**RESPONSE TO EPA COMMENTS ON DOCUMENTS PROVIDED VIA EMAIL
DATED AUGUST 13, 2018 FROM VOGEL PAINT & WAX - MAURICE IOWA
SUPERFUND SITE**

Date December 7, 2018

**COMMENTS ON REMEDIAL ACTION WORK PLAN FOR
GROUNDWATER REMEDIATION DOCUMENT**

ATTACHMENT A
LNAPL REMOVAL SUMMARY 2017

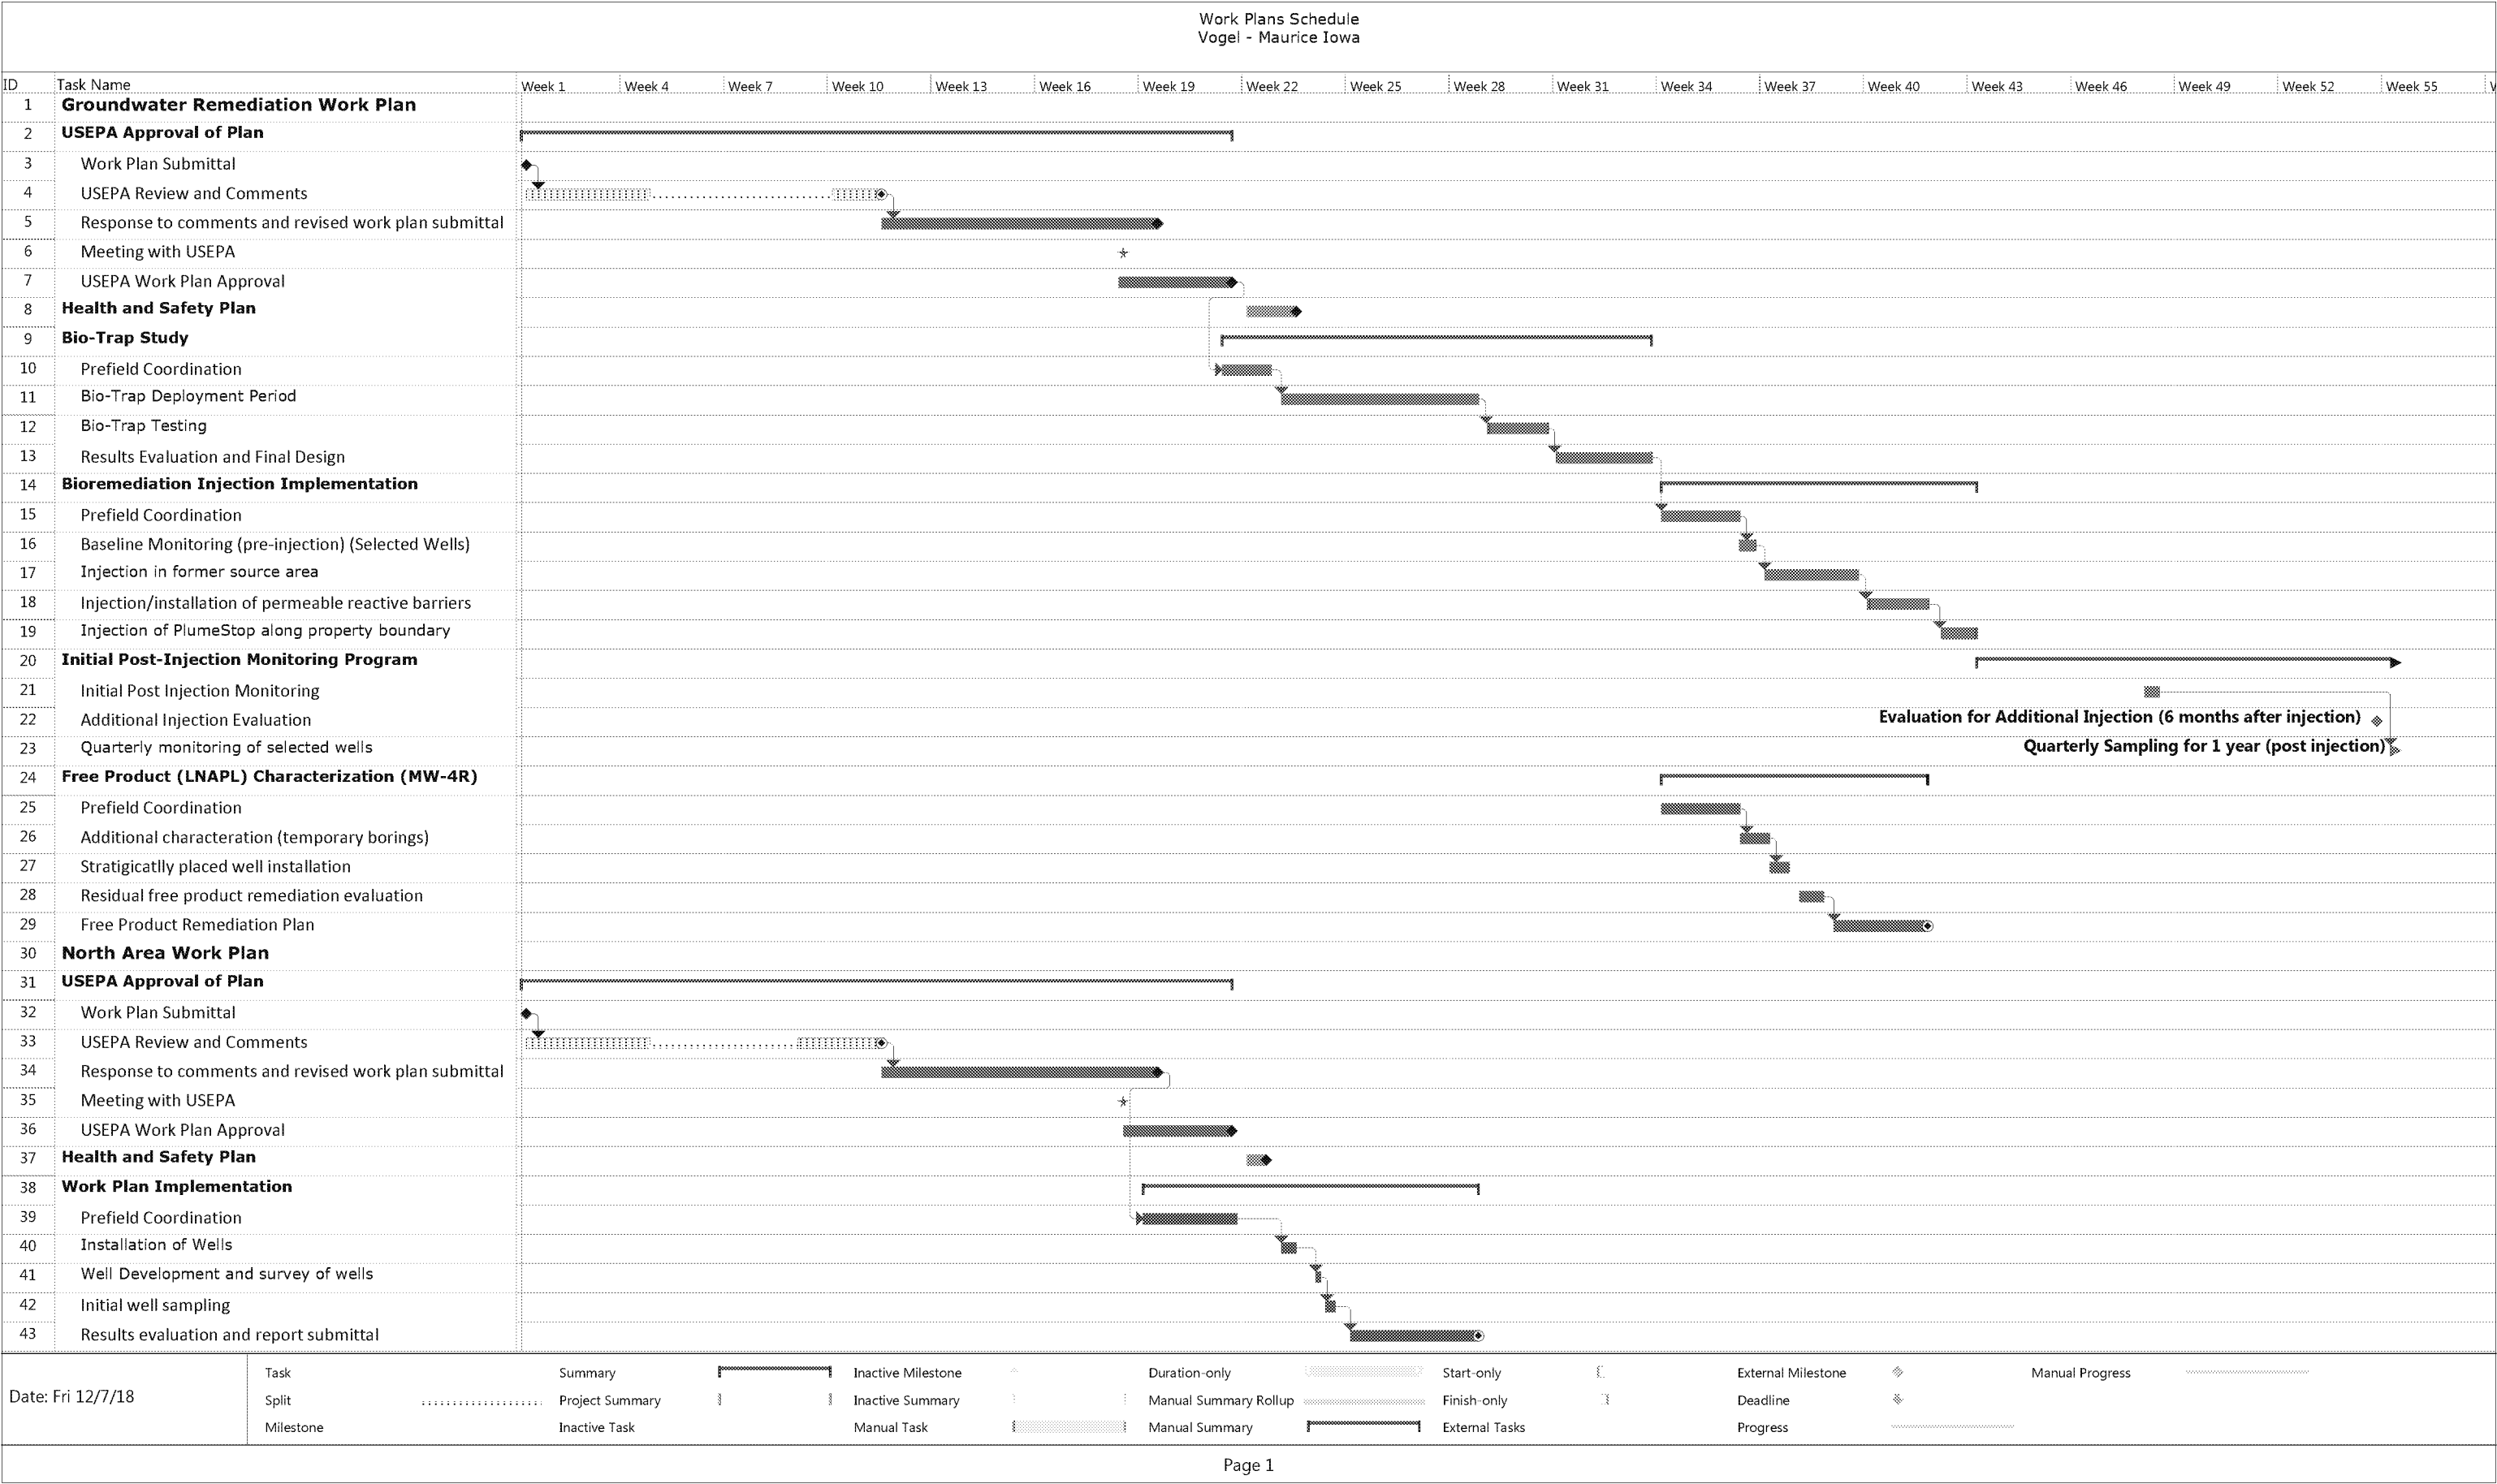
Please include an estimate for the recovery of 3.35 gallons of product.

Please see attached table (See Attachment A) summarizing the free product thickness and volume (3.35 gallons) of free product removed in 2017 by GeoTek.

Above Ground Monitoring Well Construction

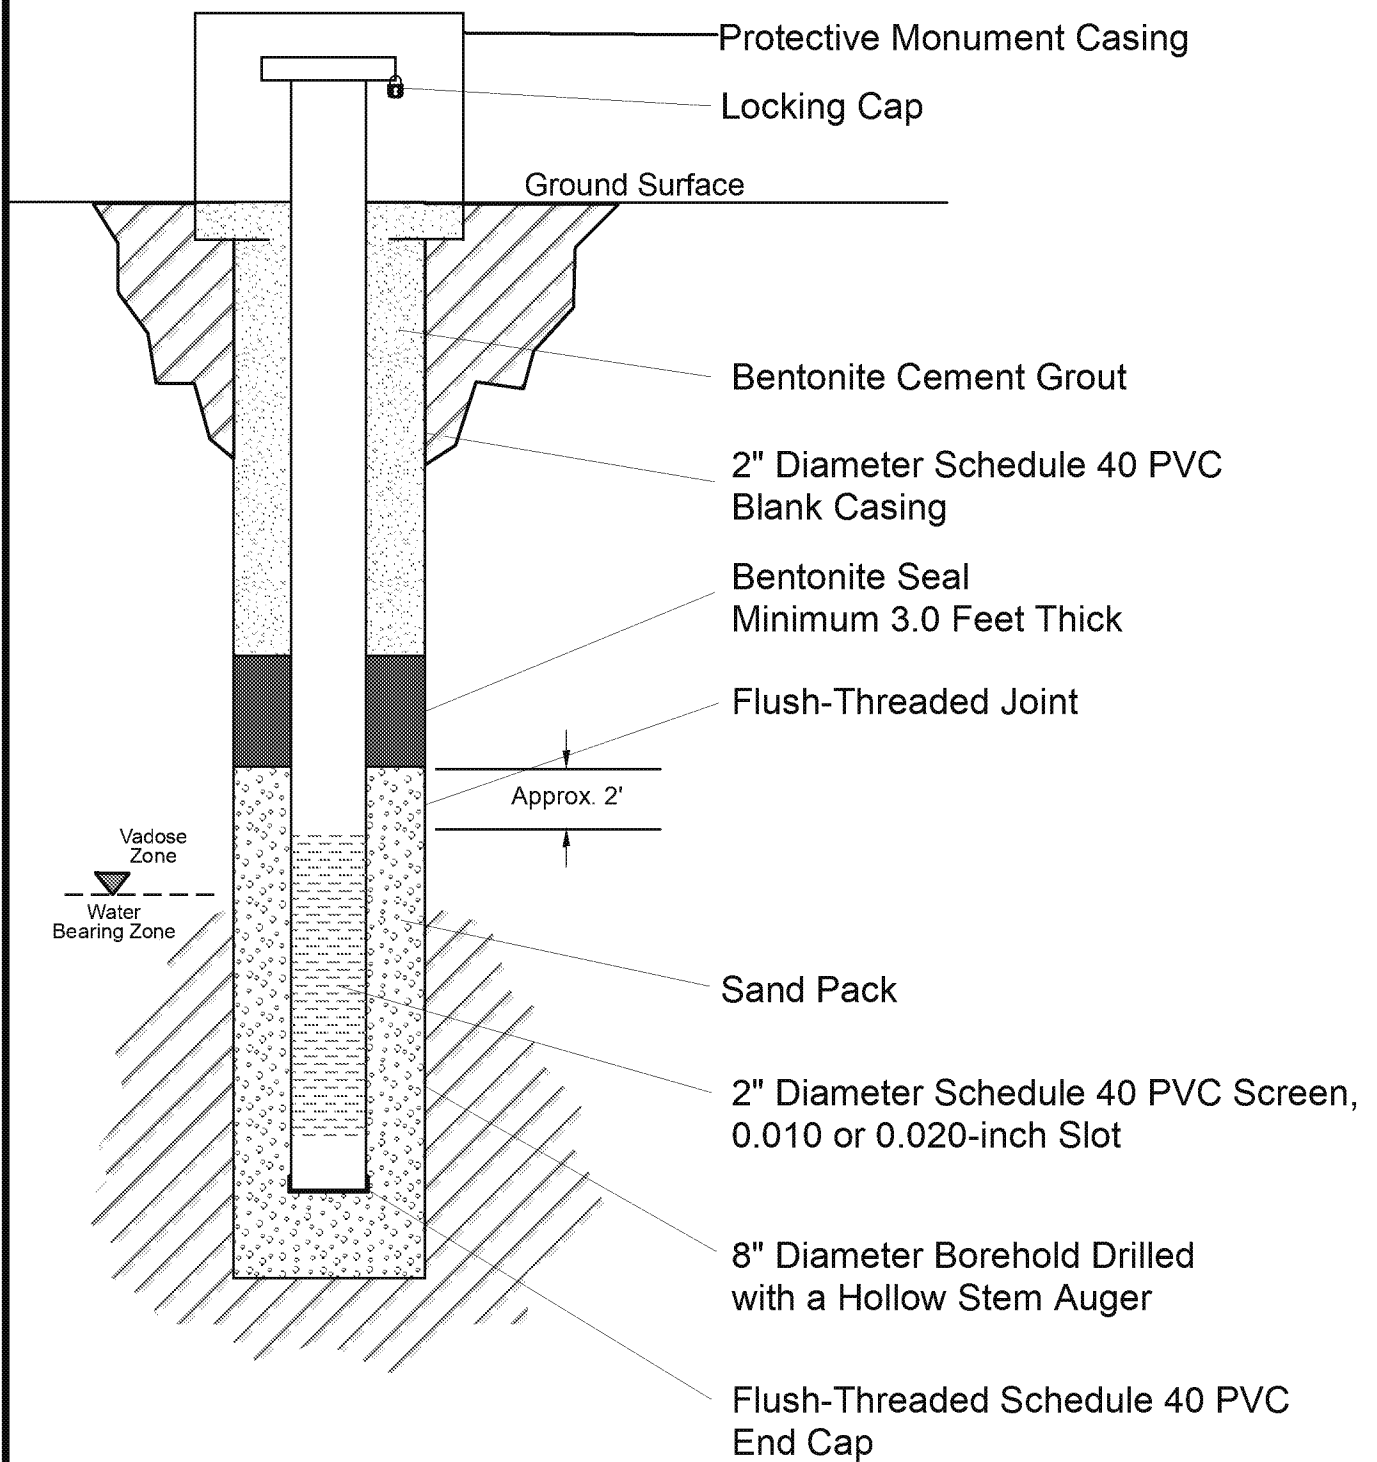
26. **Task 3.** *Figure 1 shows a typical monitoring well construction diagram depicting the installation of the well screen. Please provide the range of depths to water at the nearest existing well (GMW13), and confirm that the screen will be placed across the water table. Please add an applicable above grade well construction diagram.*

The most recent depth to groundwater in Well GMW-13 (July 2018) is 11.85 feet bgs, which is the highest water level that has been measured in this well. Depth to groundwater has ranged in Well GMW-13 from 11.85 feet to 17.93 feet. The well screen is anticipated to be from 10 to 25 feet, based on hydrogeologic conditions observed during drilling and will be placed across the water table. Figure 1 has been revised and included in the attached revised groundwater monitoring wells installation protocol (See Attachment C).
